RE: HARLOW STAGE 4 - AMENDMENTS TO CONSTRUCTION PLAN APPROVAL

Please be advised that the amended construction plans submitted to Council for Harlow Stage 4 are approved.

RE: HARLOW STAGE 4 - CONSTRUCTION PLAN APPROVAL

HARLOW ESTATE STAGE 4

**HARLOW ESTATE
STAGE 4
DRAINAGE LONG SECTION SHEET 2 OF 2
& PIT SCHEDULE**

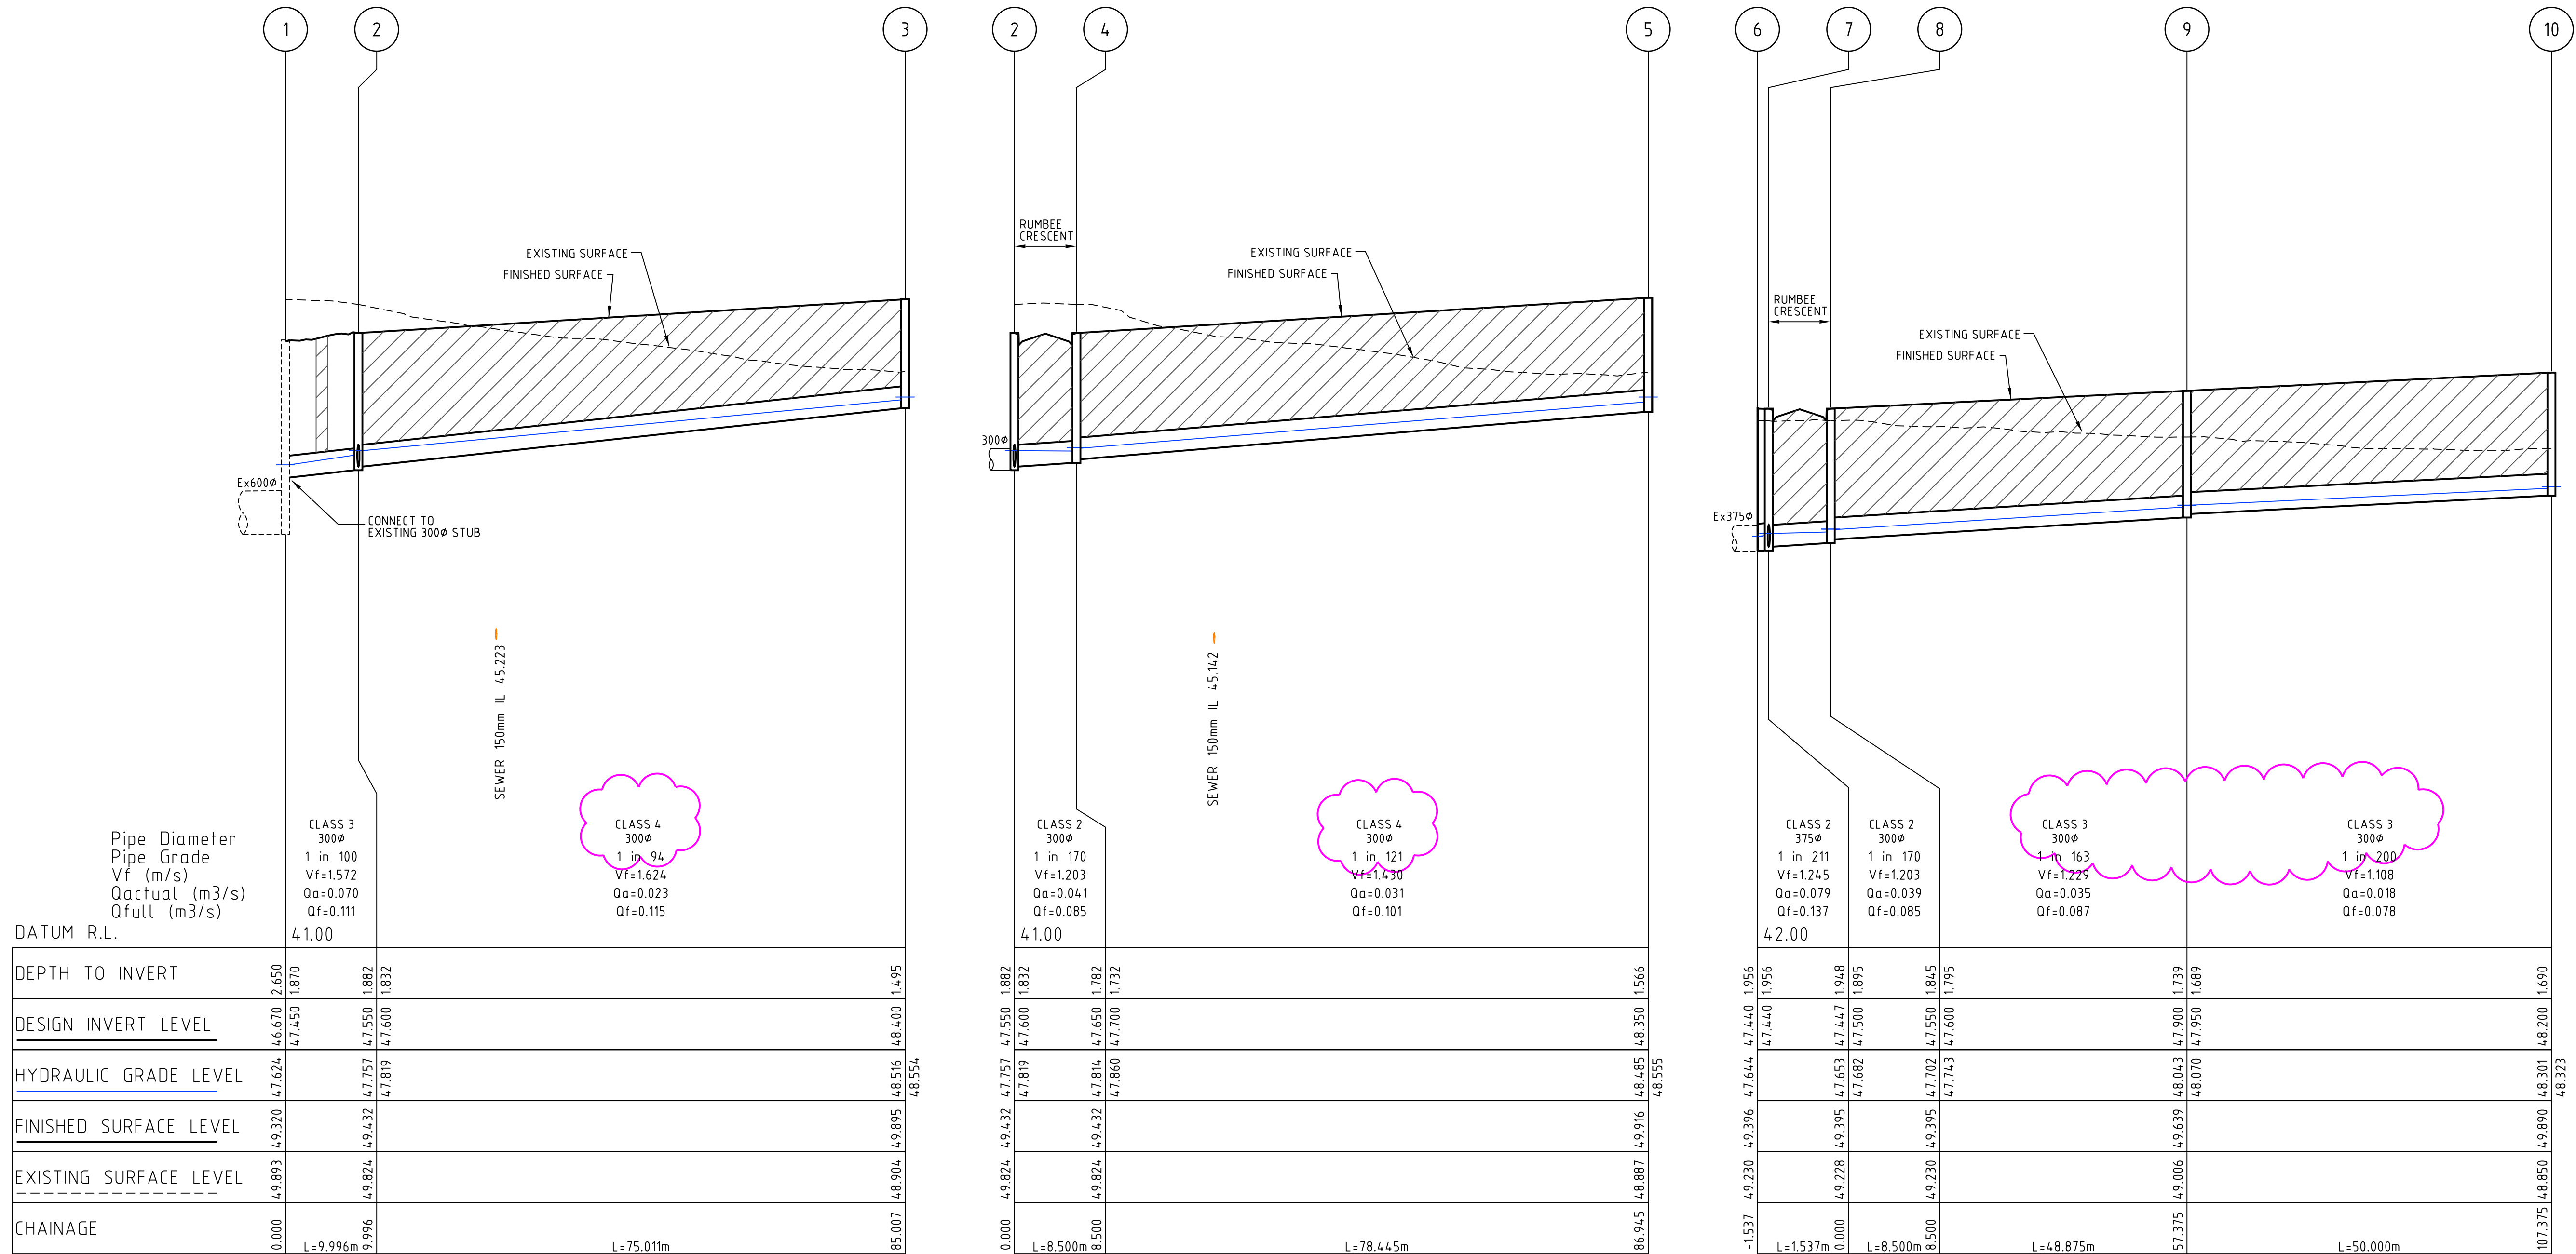
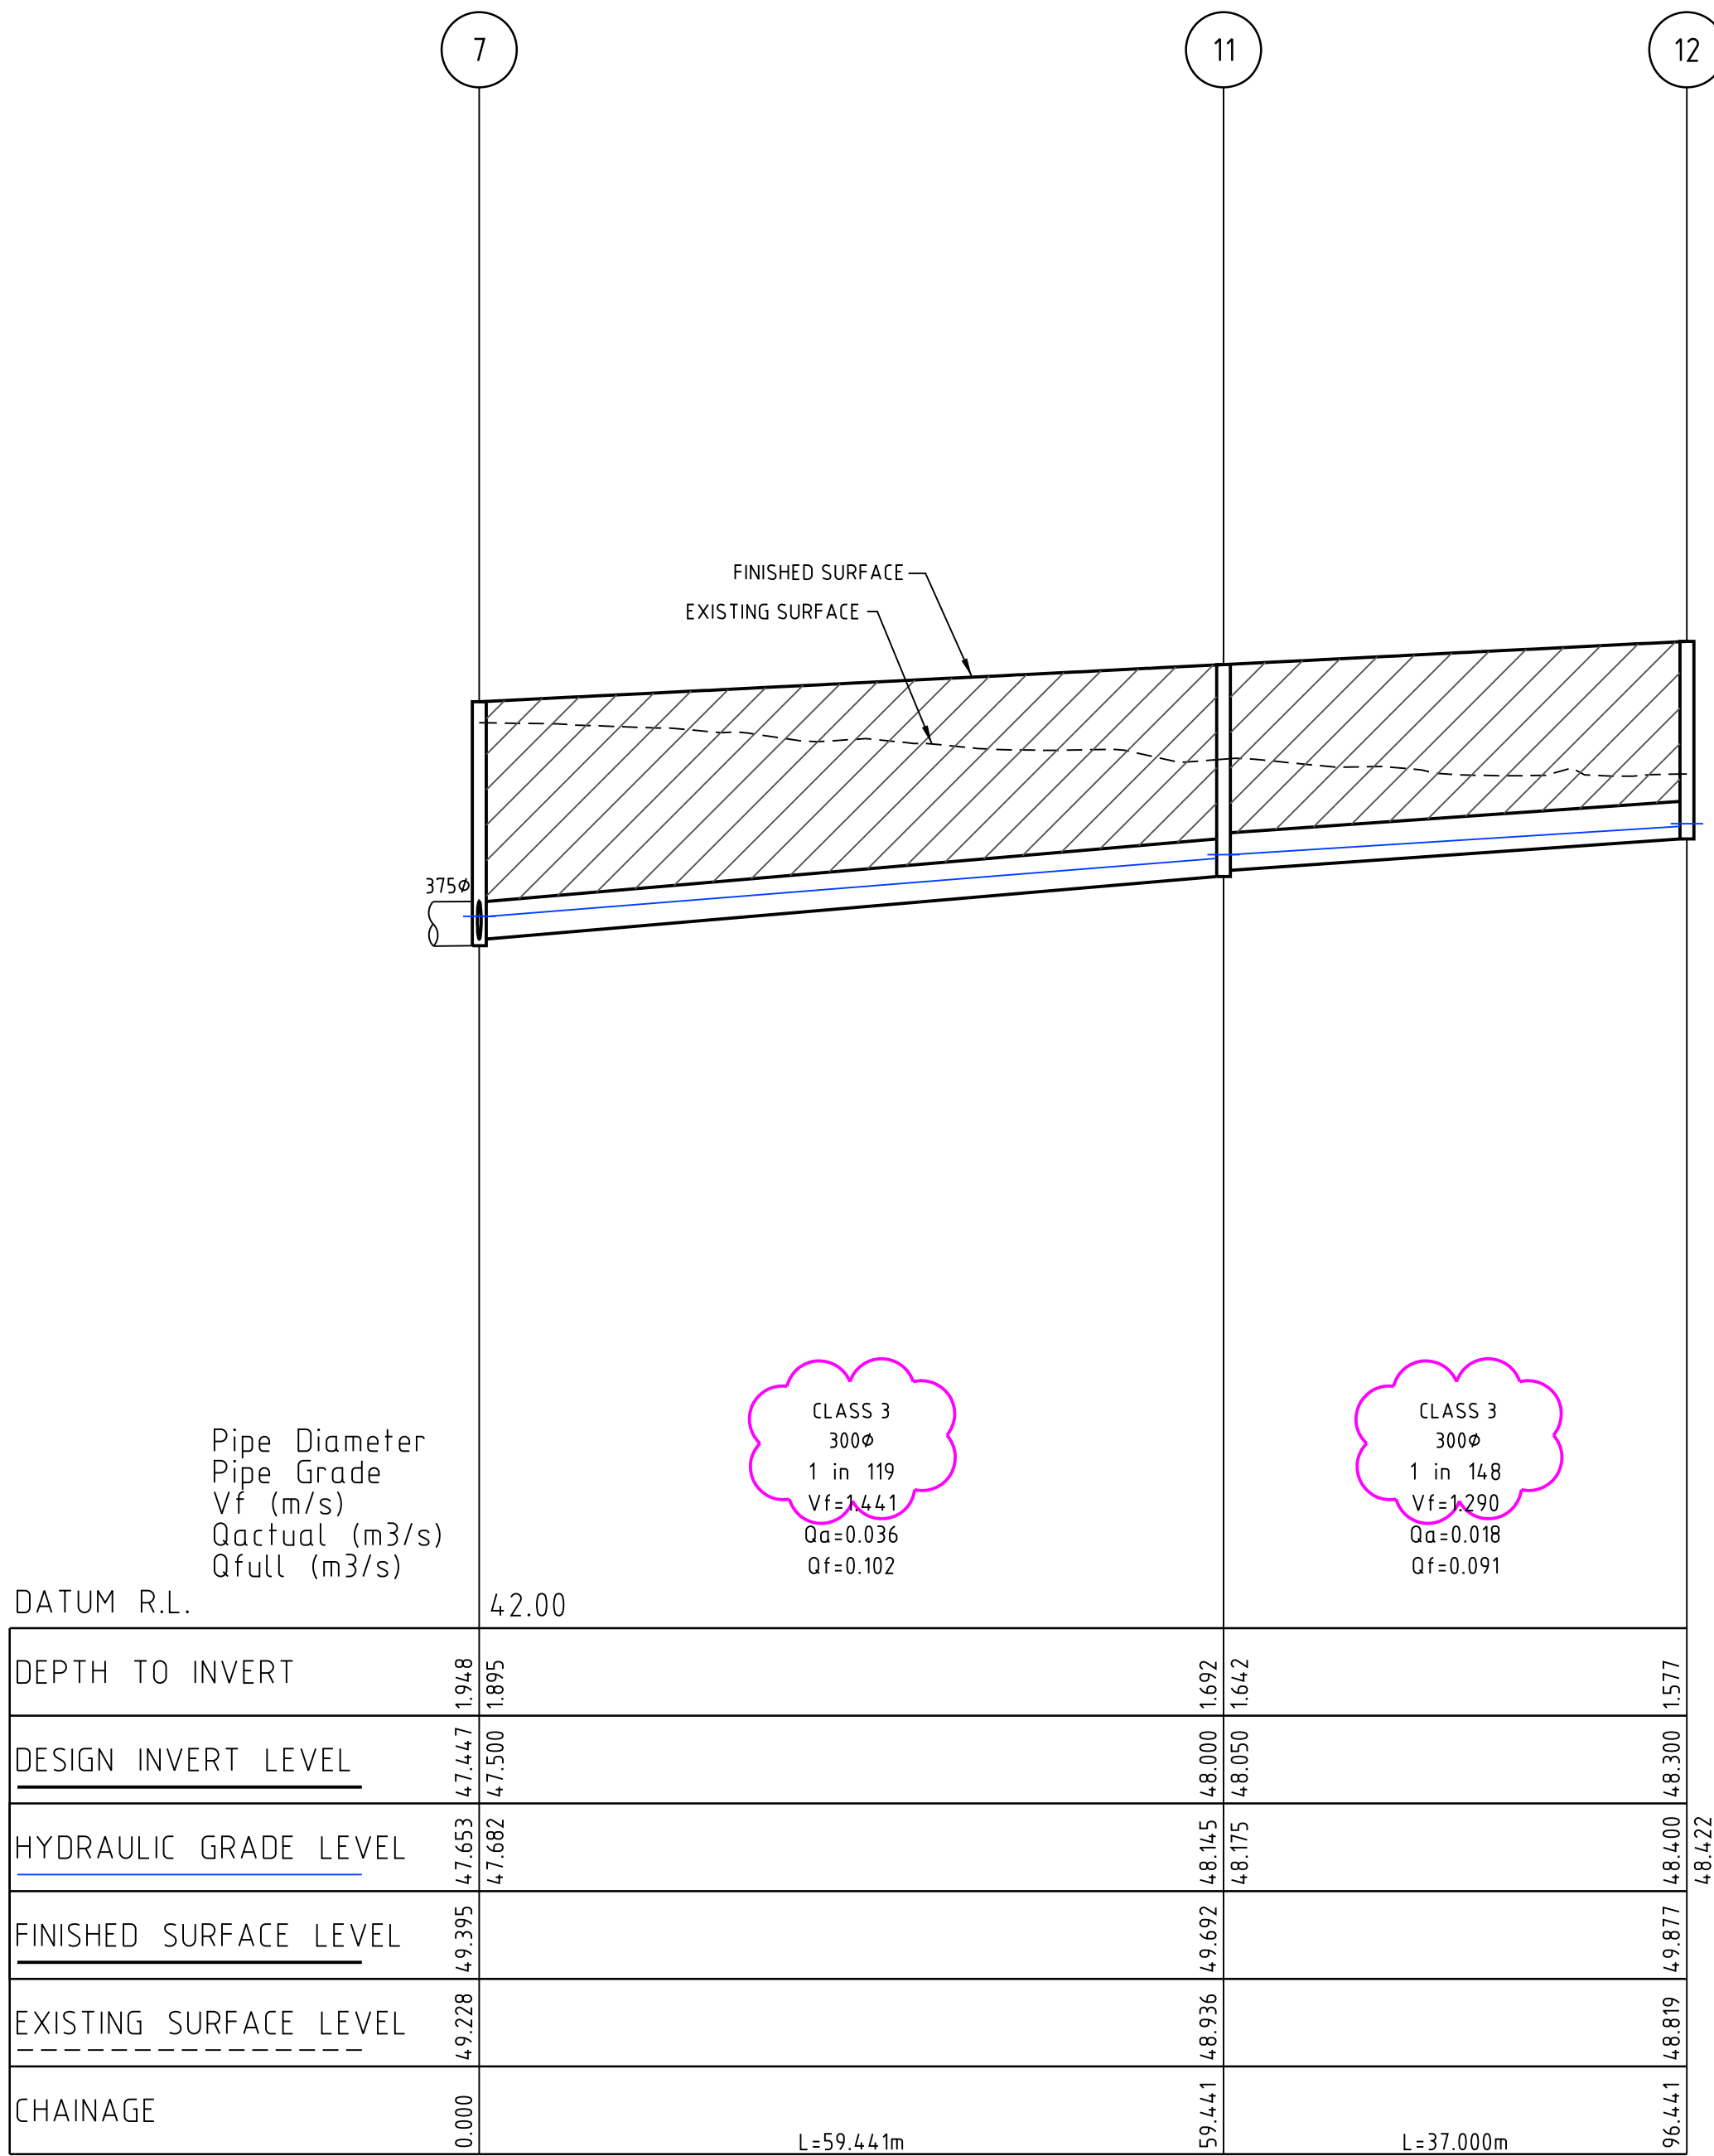
2	PIPE CLASSES UPDATED	M.R	09/02/24
1	LONGSECTIONS AND PIT SCHEDULE UPDATED	M.R	04/12/23
0	ISSUE FOR CONSTRUCTION	M.R	04/11/23
Rev	Amendments	Approved	Date

HARLOW ESTATE
STAGE 4
SIGNAGE AND LINEMARKING

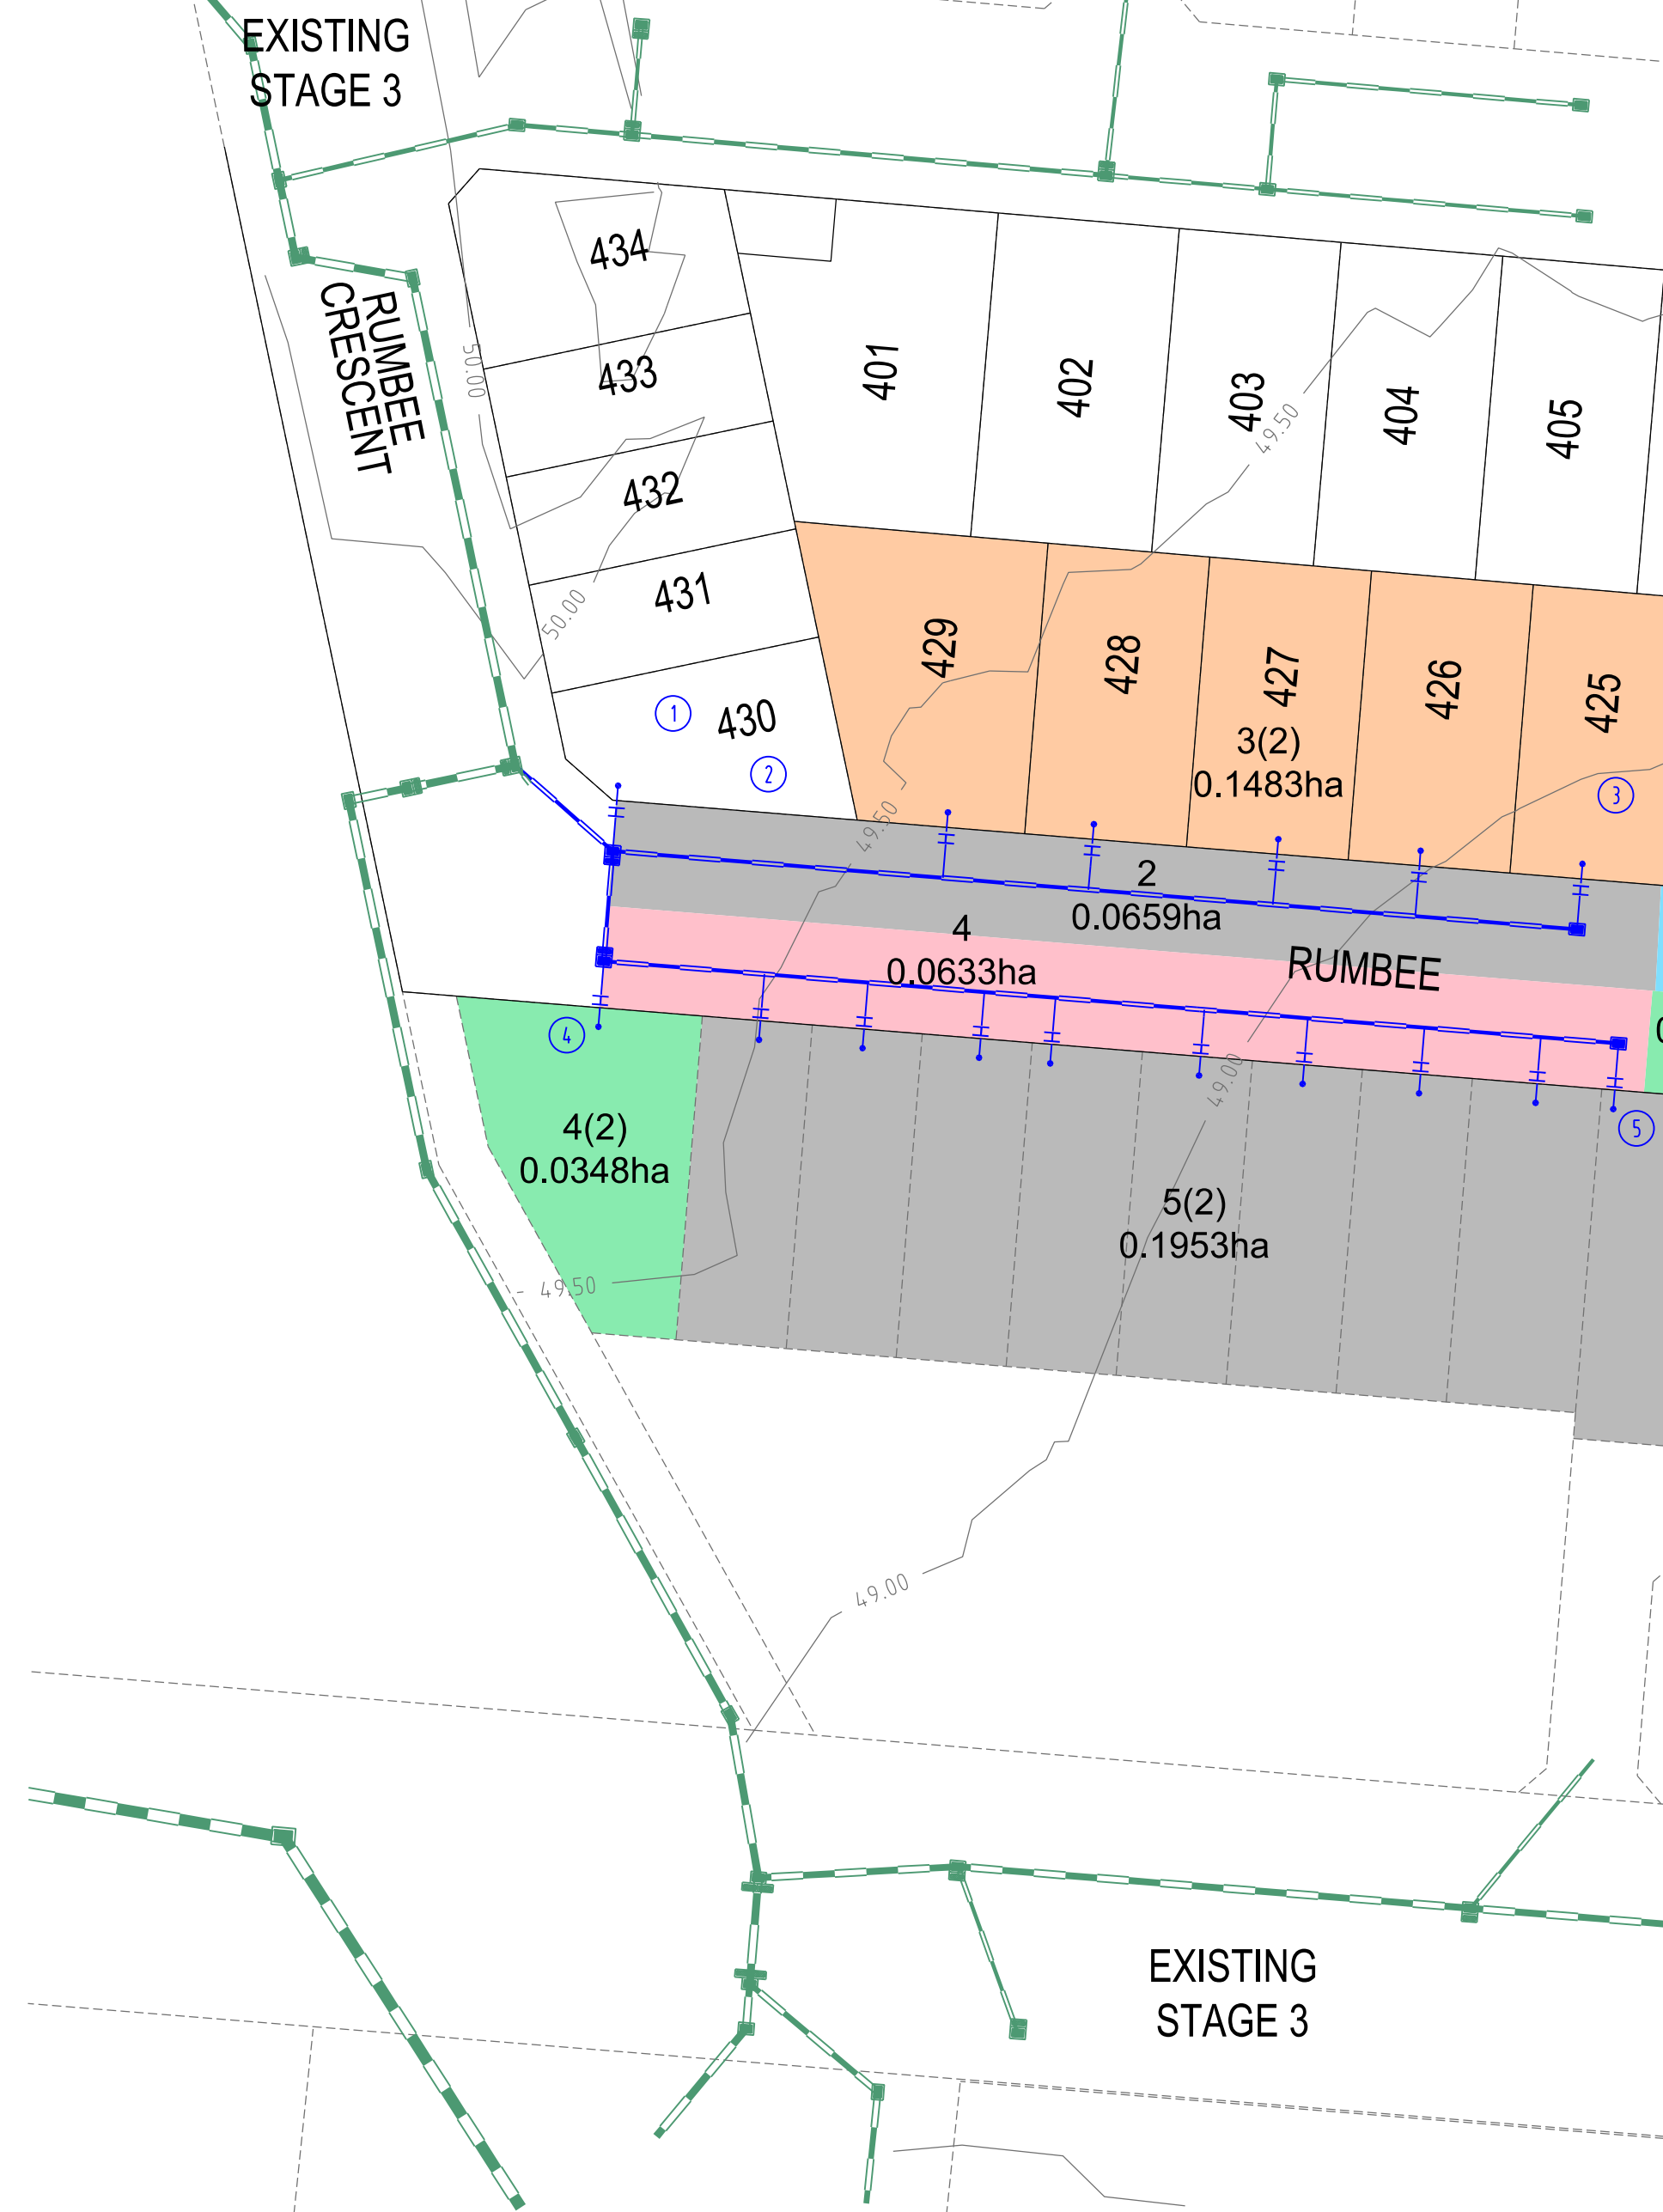
Rev	Amendments	Approved	Date
1	STAGE 5 UPDATED. HDRAIN OFFSETS UPDATED. SIGN REMOVED FRONT LOT 418	M.R	04/12/23
0	ISSUE FOR CONSTRUCTION	M.R	04/11/23
